Village of Arlington Heights
Plan Commission
Buechner Room, 1st Floor
Arlington Heights Village Hall
33 S. Arlington Heights Road
Arlington Heights, IL 60005
October 13, 2016
7:30 PM

- A. Thomas Middle School - 1430 N. Belmont Ave. - PC#16-020
Special Use for a School, Multiple Variations

RE: ARLINGTON ALE HOUSE - 111 WEST CAMPBELL STREET, 3RD FLOOR
PC# 16-019, SPECIAL USE FOR RESTAURANT, LAND USE VARIATION

C1.1

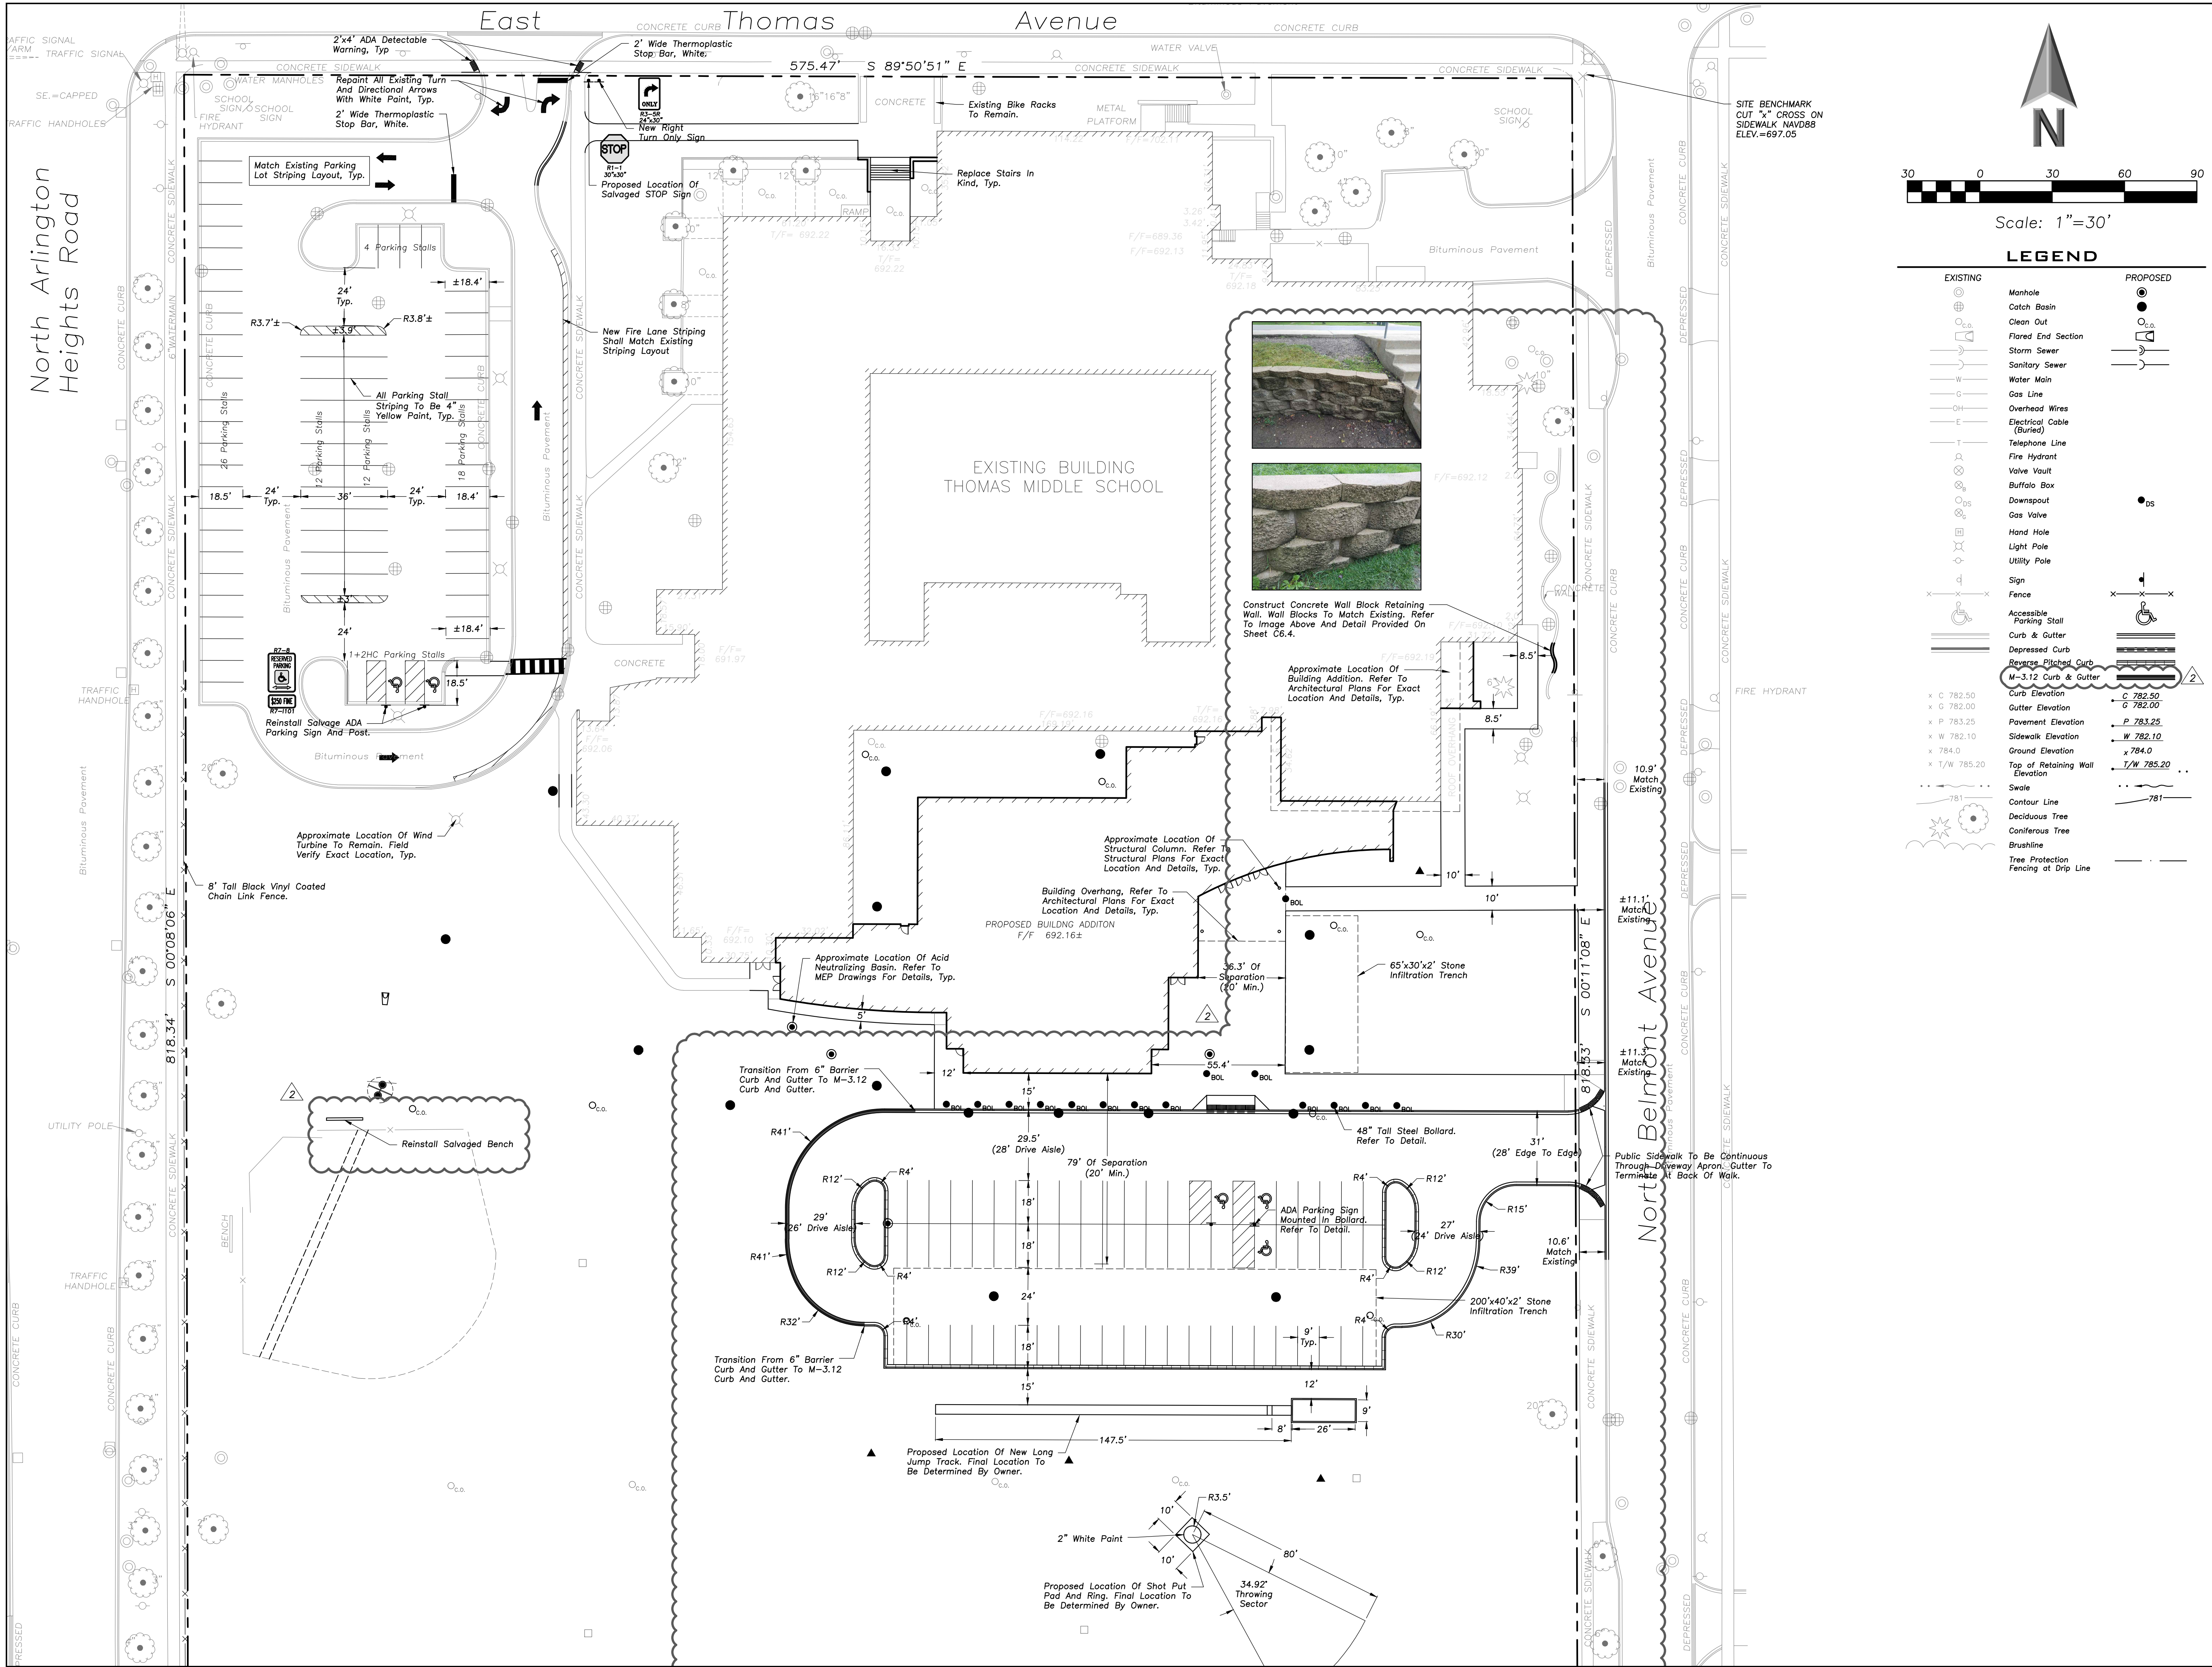
17. Consider including bicycle racks in development plan to encourage alternate modes of transportation for employees and patrons.
18. Sheet C1.1: There is an area northwest of the building that is shown to be removed on the demo plan, but is not addressed anywhere else in the plans. Is this included in the project?

18. Sheet C1.1: There is an area northwest of the building that is shown as to be removed plan, but is not addressed anywhere else in the plans. Is this included in the project?

A note has been added to Sheet C1.1 calling for the condition of any traffic signage to be verified in compliance with MUTCD requirements prior to reuse.

Sheet No: **C3.1**

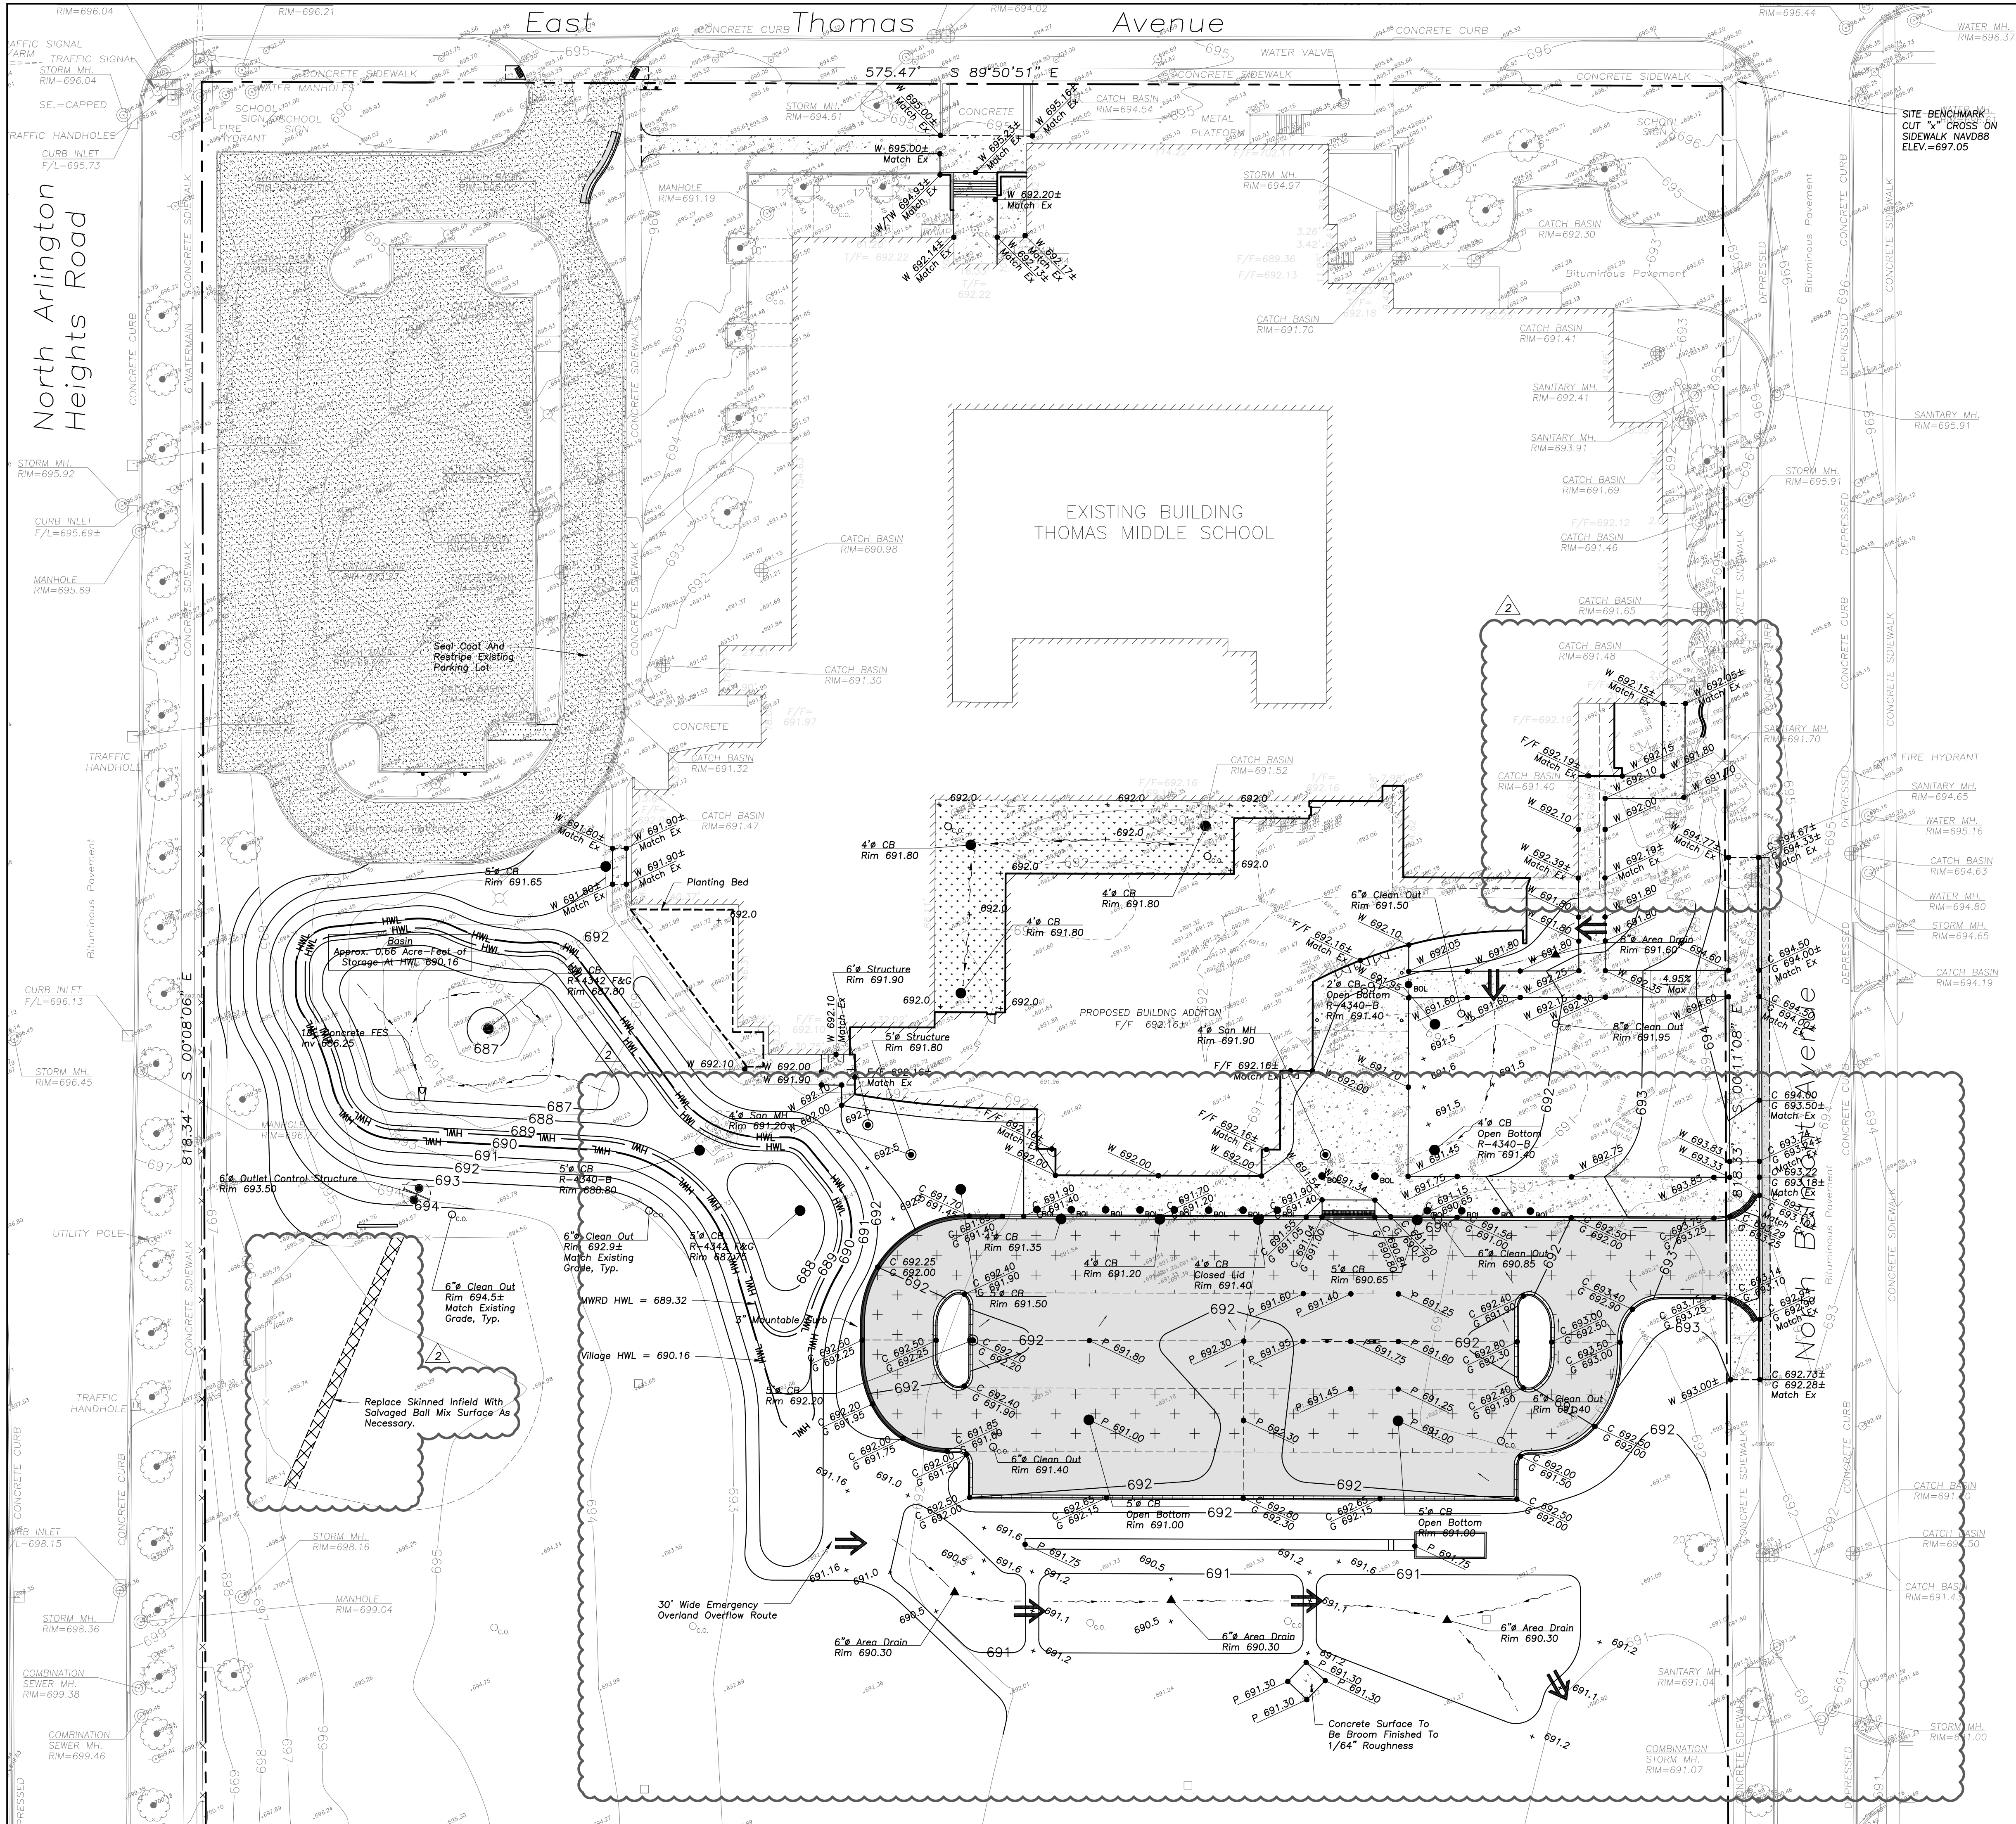
19. Sheet C3.1: There is an existing north-south 6" PVC sewer line shown per the record drawing south of the new building addition. This existence and function of this line must be verified prior to approval.

19. Sheet C3.1: There is an existing north-south 6" PVC sewer line shown per the record drawing south of the new building addition. This existence and function of this line must be verified prior to approval.

The existence of the PVC storm sewer shall be investigated. Upon an initial site visit the structures shown on the record plan were not located. Notes calling to field locate and verify the 6" storm sewer has been added to Sheet C3.1.
